RESOLUTION NO. R- 2384

A RESOLUTION OF THE CITY COUNCIL OF THE CITY OF KIRKLAND APPROVING THE ISSUANCE OF A FINAL PLANNED UNIT DEVELOPMENT AS APPLIED FOR IN DEPARTMENT OF COMMUNITY DEVELOPMENT FILE NO. PUD-76-41(P), BY VILLAGE UNIVERSAL OF WASHINGTON TO CONSTRUCT A 26-UNIT CONDOMINIUM DEVELOPMENT OF "SUNSET CONDOMINIUMS" BEING WITHIN A WATERFRONT DISTRICT I ZONE, AND SETTING FORTH CONDITIONS TO WHICH SUCH FINAL PLANNED UNIT DEVELOPMENT PERMIT SHALL BE SUBJECT.

FILE NUMBER SDP-PUD-76-41(P) FINAL  
 APPLICANT VILLAGE UNIVERSAL OF WASHINGTON  
 PROPERTY LOCATION South of 733 Lake St. So.  
 SUBJECT Applic. for FINAL Planned Unit Development and Substantial Development Permit for "SUNSET CONDOMINIUMS"  
 HEARING/MEETING DATE \_\_\_\_\_  
 BEFORE \_\_\_\_\_

EXHIBIT "A"  
 SITE PLAN/VICINITY MAP  
 SDP-PUD-76-41(P) Final  
 Sunset Condominiums

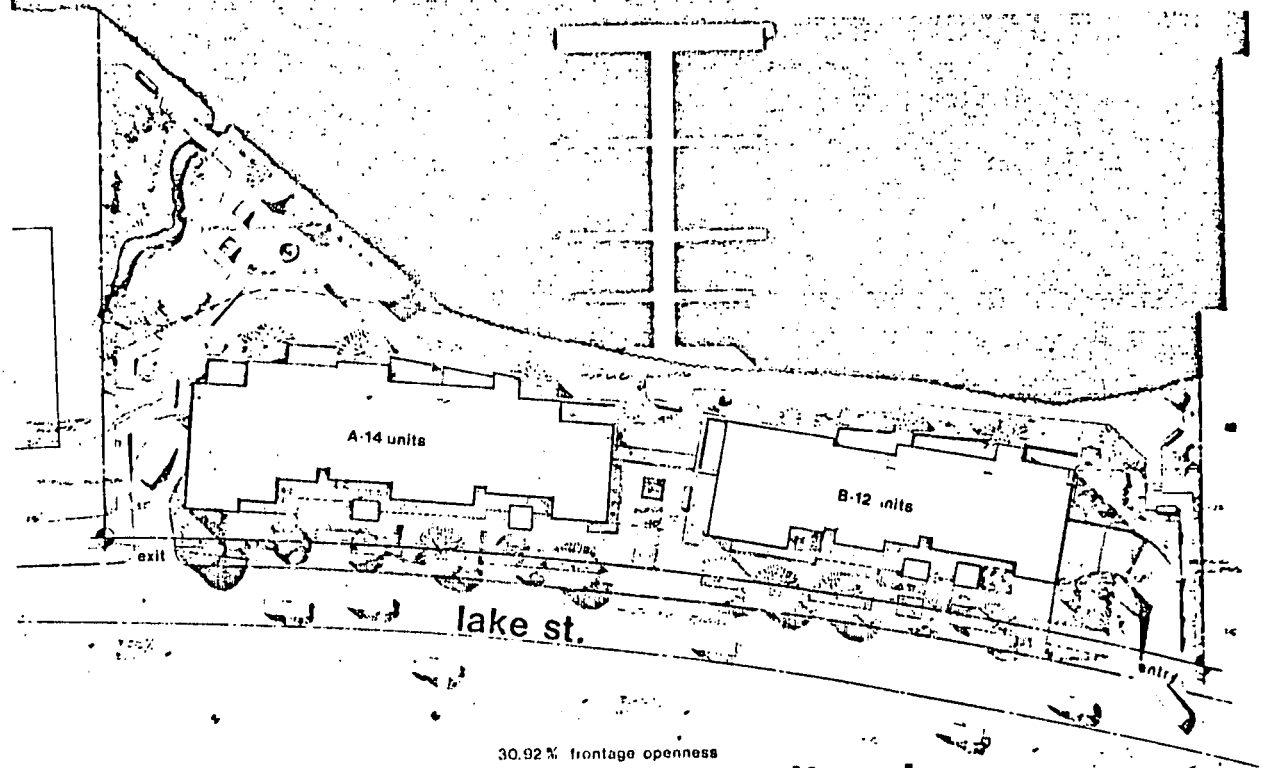
- A. 4. (Cont'd)  
Kirkland harmless for any claims for injury or damages resulting from improper maintenance of that area. Further, the applicant shall be required to submit an exhibit which indicates the physical areas where public access is being permitted on the subject property. Further, Exhibits "A" and "K" shall be modified to include a 6 foot wide hard surface ramp in the north property line setback from the location of the proposed entry driveway to the waterfront trail area. This shall be in addition to the public pathway as indicated on that exhibit.

- G. LOCAL ZONING AND/OR LAND USE POLICIES AND PLANS:
8. Pursuant to Resolution No. 2359, the following are relevant:
- The applicant shall be required to modify Exhibit "A" to comply with the Shoreline Hearing Board Order of Dismissal. With this addition, the proposed public access area will be accessible for handicapped and disabled persons.

- G. 8. - 1. (cont'd)  
tion of the proposed facility is feasible using the conventional shallow spread footing system and that a professional engineer did not foresee any adverse geologic impacts or stability problems resulting from construction of the proposed facility.
- m. The proposed pier has been moved a considerable distance to the south, and is essentially located in the center of the subject property. The length of the main pier structure has been reduced from approximately 200 feet to 131 feet in this proposal. Said pier should be constructed with a standpipe under the main deck which would be adequate to utilize as a component of the sewage pumpout facility if such a facility is needed in the future.
- n. As indicated on Exhibit "A", the proposed site plan indicates 30.91% frontal openness along Lake Street South.

- b. That the applicant shall modify Exhibits "A", "H", "I" and "J" to include a 6 foot wide aggregate concrete pathway from the entry driveway to the north property line setback area to the water's edge pedestrian way which is in addition to the public access already indicated there and is consistent with the Order of Dismissal from the Shoreline Hearing Board of SHB NO. 222.
